Rezoning Transportation Analysis

Petition Number: 2020-103

Date	Description
08-23-2020	First Review
09-29-2020	Second Review

Proposed Site Plan:
(with 64.9 feet R/W per survey):
Sept 2020

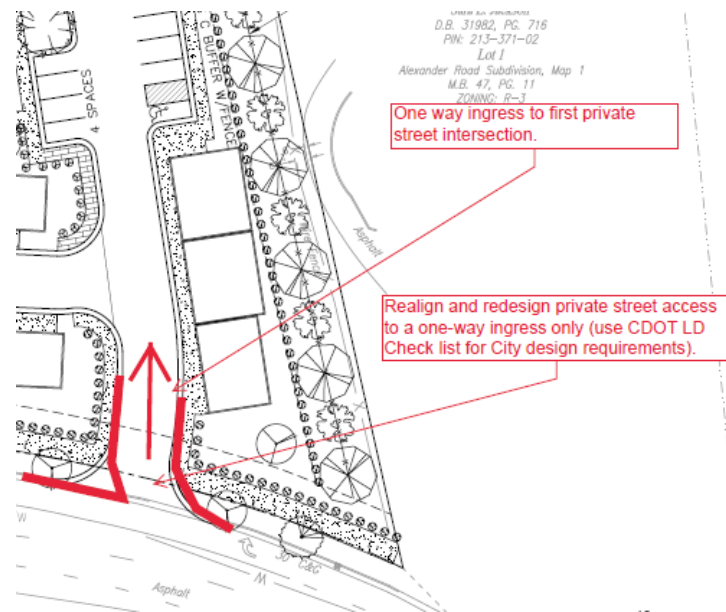
- (Revised Comment 09/23/2020):** The petitioner will maintain the existing public right-of-way along Providence Road of 64.9 ft (per deed survey) from the Providence Road's centerline to the subject property line. The site plan should label and dimension the right-of-way from the road centerline. The deed survey reconciles any inconsistencies shown on Charlotte Explorer of 100' foot right-of-way. ~~The petitioner should revise the site plan and conditional note(s) to commit to dedicate 50-foot right of way from the Providence Road centerline. The site plan should label and dimension the right-of-way from the road centerline.~~

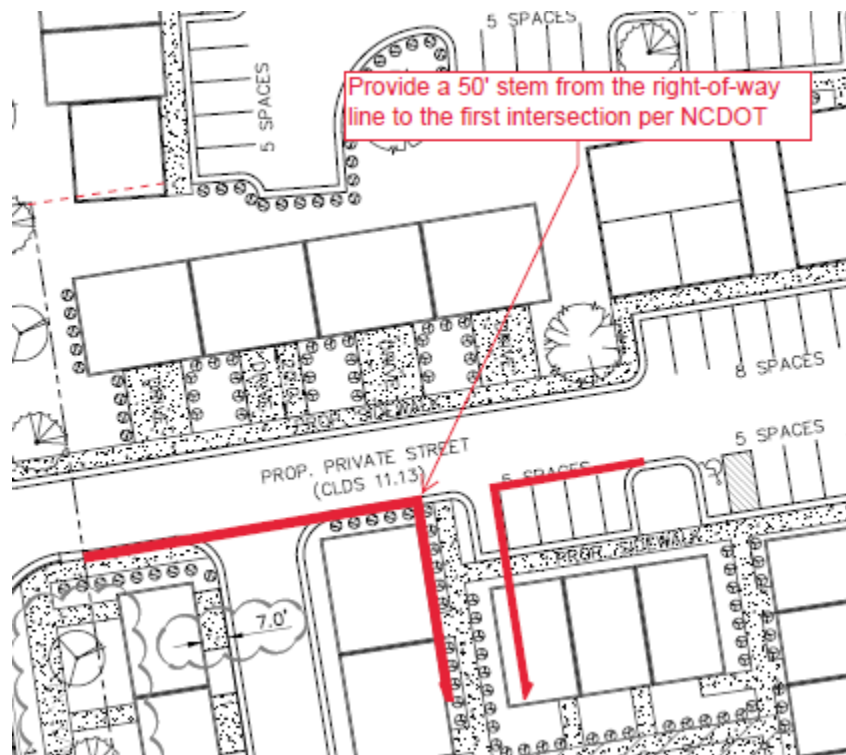
9. **New Comment per revised site plan (9/29/2020):** The petition is requesting an Urban Residential – 2 (UR-2) Zoning District, which provides regulations on public and private street design for conditional plans. The petitioner shall revise the Alexander Road site plan to realign and redesign

private street access to a one-way ingress only (refer to the CDOT LD checklist for City design requirements). Feasibility of a raised median on Alexander Road shall be considered.
